PLANNING COMMITTEE – THURSDAY 16TH NOVEMBER 2023

22/1764/FUL - Demolition of existing building and erection of retail food store, (Use Class E(a)), with associated access, parking and amenities at World Of Water, Hempstead Road, Watford, Hertfordshire, WD4 8QG

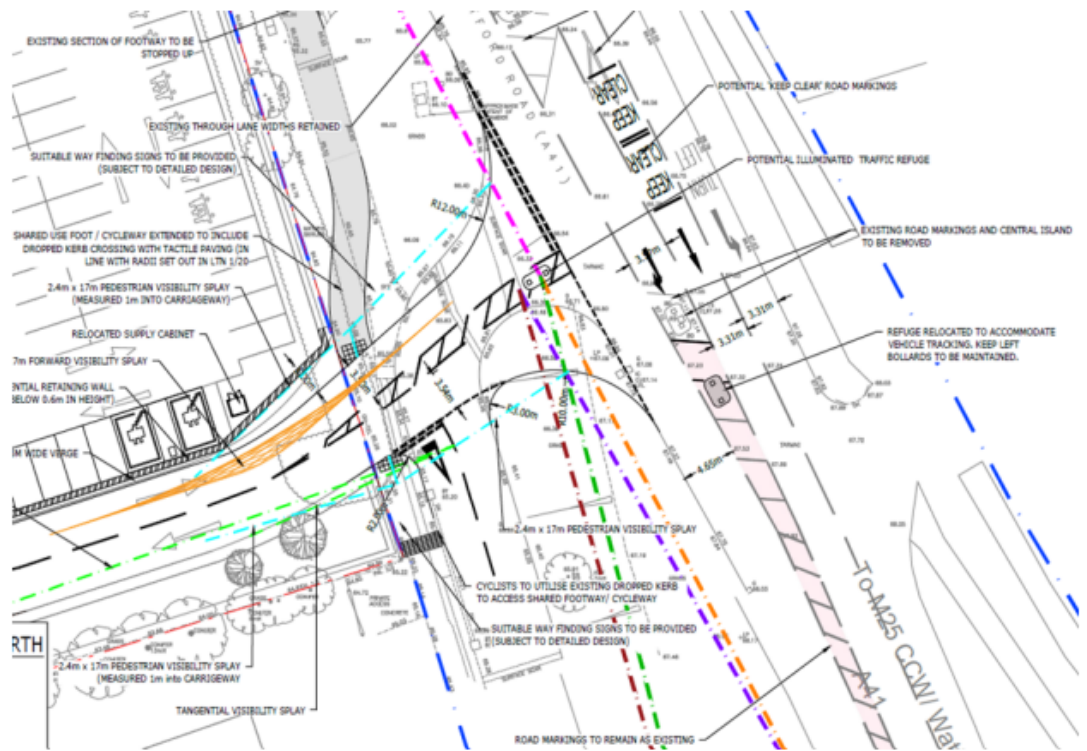
The site is presently accessed from a large priority junction which provides access to the World of Water aquatic centre, an adjoining café and military goods store and dwellings.

The above access presents a number of engineering challenges with the proposed foodstore usage to which the applicant's transport consultant has responded to, subsequent to comments made by the Highway Authority. This has included comments on visibility (both horizontal and vertical), vehicular access for large vehicles, geometry and turning into the site from both directions.

The Highway Authority has noted that safe and suitable access will need to be provided for goods vehicles servicing the proposed foodstore, that satisfactory visibility is ensured (in particular towards Hunton Bridge) and active travel is promoted.
